Appendix E – Response to Comments

**Response to Comments
on the
Draft Environmental Impact Statement for the
MHA Nation's
Proposed Clean Fuels Refinery Project**

Figure 1 -- Plat designation for North East Boundary for Fort Berthold Reservation
1911

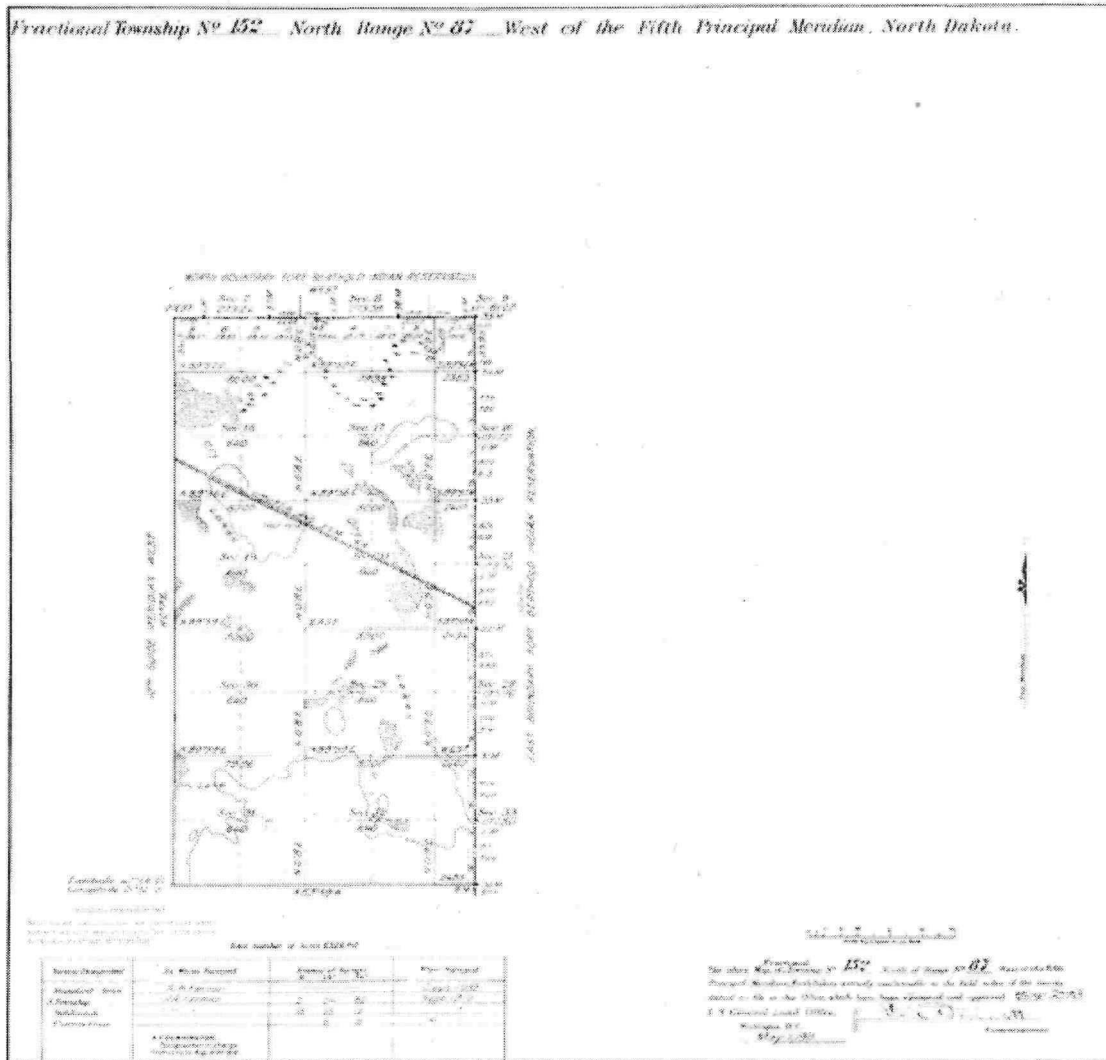
Comment 8: Comment that this project is not located within the exterior boundaries of the Fort Berthold Reservation

Response 8: The legal description for the project site is described as: N½ of Section 19, and the NW¼, Section 20, both located within Township 152 North, Range 87 West, 5th Principal Meridian, Ward County, North Dakota, containing 468.39 acres more or less after consideration of existing easements. This land is located on fee land within the exterior boundaries of the Fort Berthold Reservation. The following figure indicates the official north-east corner of the Fort Berthold Reservation.
